Bulletin No. 2002-06

## Correction of Leak at Nosecone of Pinpoint Hybrid Lower Units

**a** - MXP22802 0.50 in (12.7 mm)

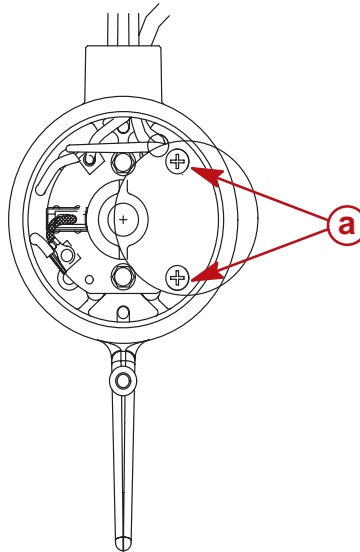
The o-ring that seals the nosecone is not being properly compressed, allowing water to leak into the lower unit.

Replace two of the existing 0.75 in. (19.05 mm) long screws that connect the commutator cap to the transducer nosecone. These screws, located on the side opposite from the mosfet board, are to be replaced by part number MXP22802, which is 0.50 in (12.7 mm) long.

**IMPORTANT: Correct positioning of these two screws is critical to the proper compression of the commutator cap-to-nosecone o-ring. Apply CLEAR ATV sealant between the nosecone and the commutator cap to create an additional protective seal.**
